Deering-Swain Hse, post-1846 (probably 1850's) Tuscaloosa, AL. H.R. Jones photos
Mar 1983 1 of 6

Re: Dearing-Swaim House
Tuscaloosa

HISTORICAL & RESTORATION COMMENTS:

SERVICE WING ALTERATIONS - SCHEMATIC

DEARING-SWAIM HSE
1ST FL. SERV. WING OVER
1 CM. = 5' ±
6 MAY 1980

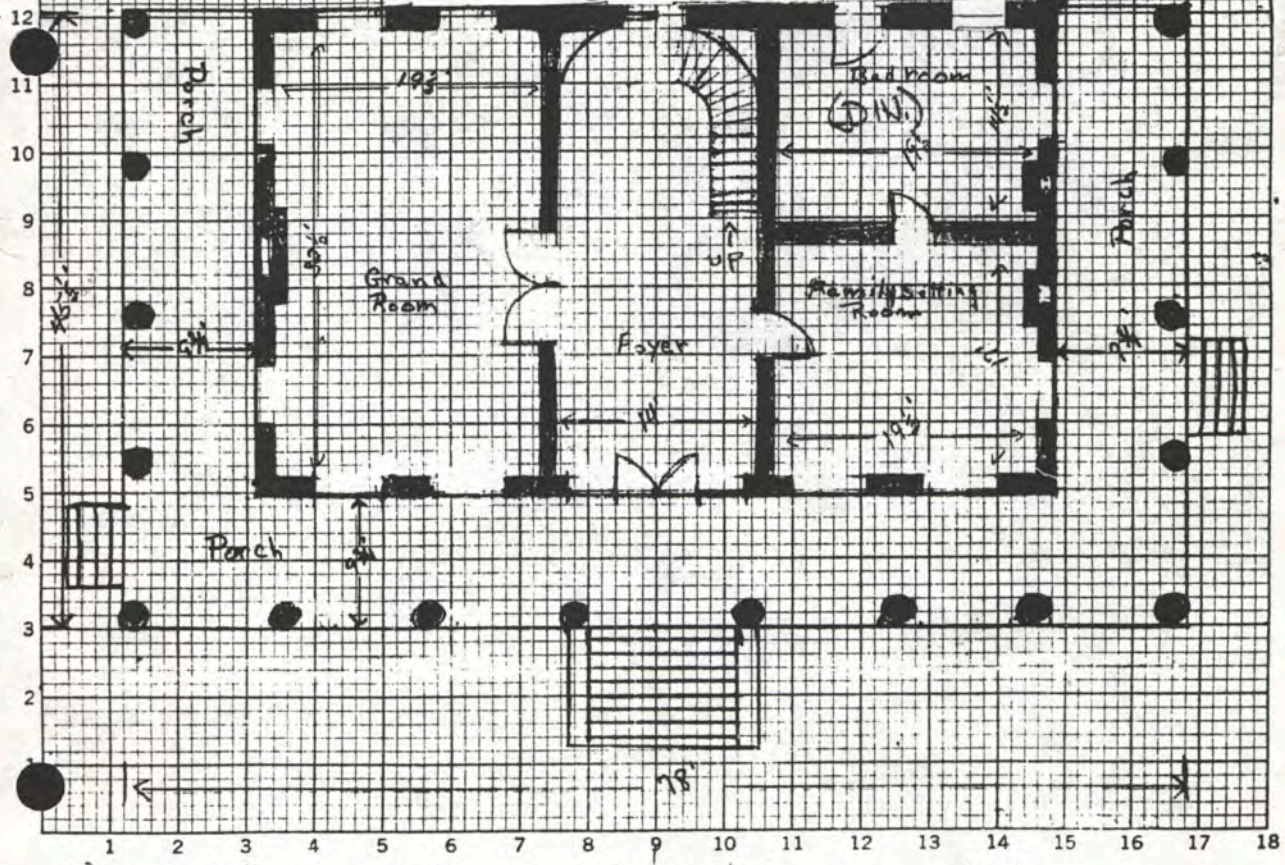
Main Hse reputedly is ca. 1946 - may be 1850's based on cast knobs

Swain - a the you - show 1st floor on 1887 birds-eye

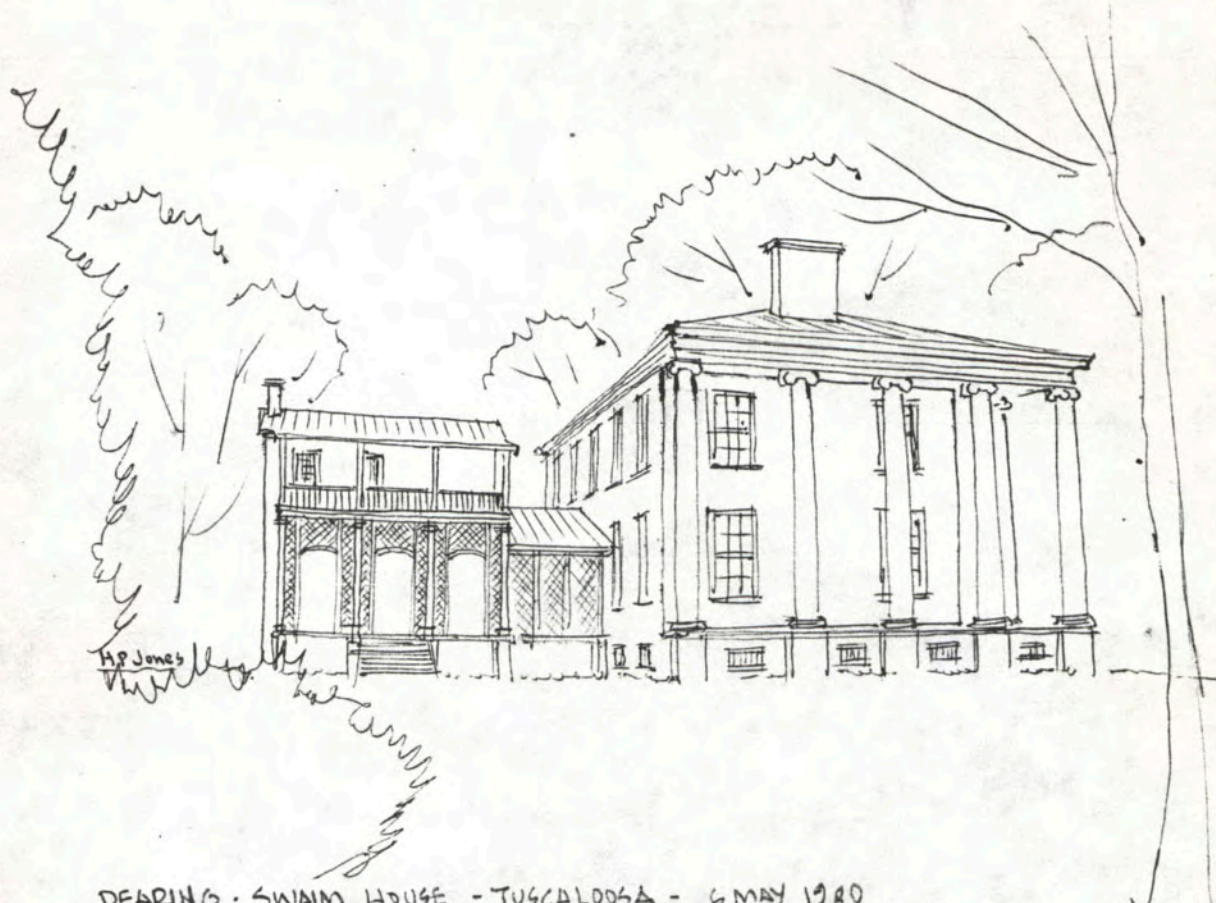
(H) Demol. Section
